OP-INV-93 - Gordon Crosby

As far as I am able to tell, Volume 6, Section 3 Part 5, with the title “The geometric design of pedestrian, cycle and equestrian routes” dated 2005 is the current version and appears to be directly applicable to the S08 situation.

Figure 7.1: Boundary treatments for NMU Routes

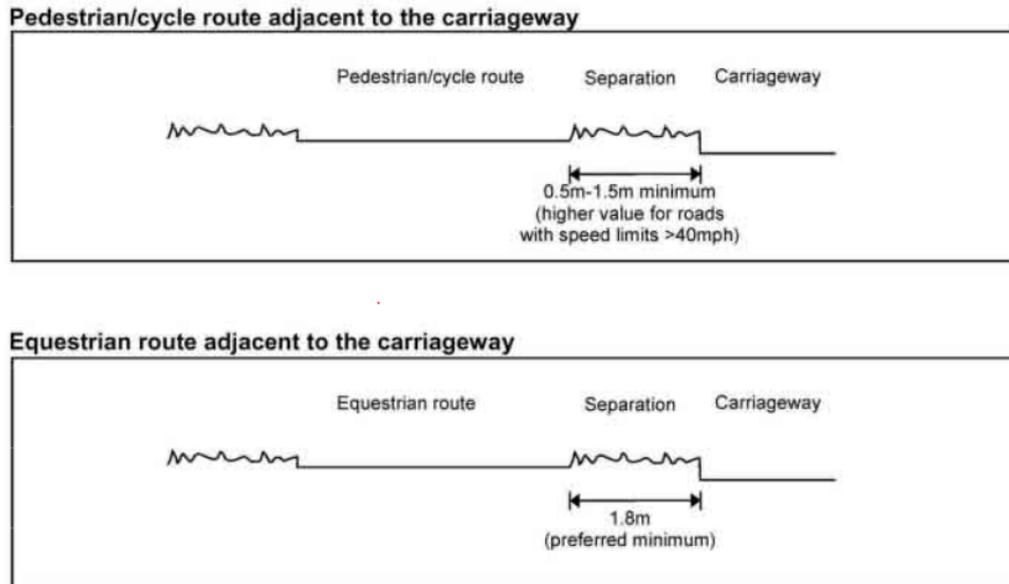
The proposed diversion route for S08 is alongside the B1113 where the National Speed Limit applies; 60mph for cars and 50 for lorries. It follows that to meet the recommendations of the DMRB the width of the footpath should be 2.0 metres and this should be separated from the carriageway by a further 1.5 metres. In fact the route should be slightly wider as it is bounded on the East side by a bank.

For a significant part of the diversion the route falls well short of these recommendations.
